# UNITED STATES PATENT AND TRADEMARK OFFICE

10/528,516

<b>Office Action Summary</b>	<b>Application No.</b> 10/528,516	<b>Applicant(s)</b> SHARAIHA ET AL.	
	<b>Examiner</b> Trinh Vo Dinh	<b>Art Unit</b> 2821

### **DETAILED ACTION**

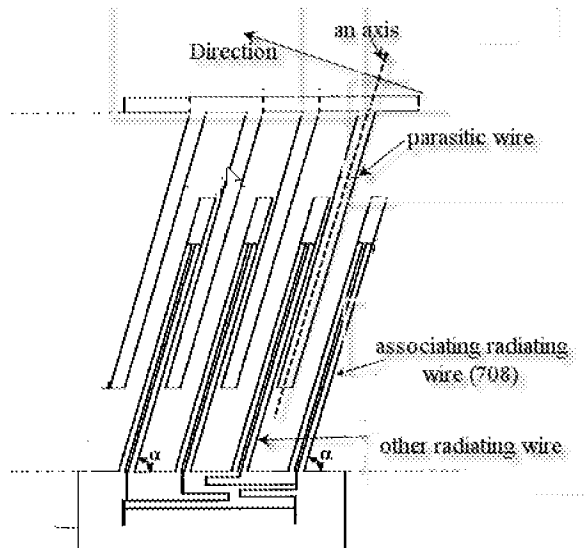
Respecting claim 1, Fillipovic 847 discloses a helical antenna including at least one helix (Fig. 8B) consisting of at least two radiating wires (708 in Figs. 8b or 12), each of them being connected by coupling to an associated parasitic wire (710) by one first

end (col. 6 lines 30-45, col. 7 line 65 to col. 8 lines 12), said radiating wires (708) and parasitic wires (710) being parallel and having a same length (Figs 11, 12) wherein a width of each of said parasitic wires is narrow than or equal to a width of an associated radiating wire (Figs. 11-12 shows width of each parasitic wires 710 is equal to width of an associated radiating wire 708). Further, Fillipovic 847 discloses each of said parasitic wires (710) is farther in a direction perpendicular to an axis of said parasitic wires from said associated radiating wire than from at least one of said other radiating wires (see the below drawing).
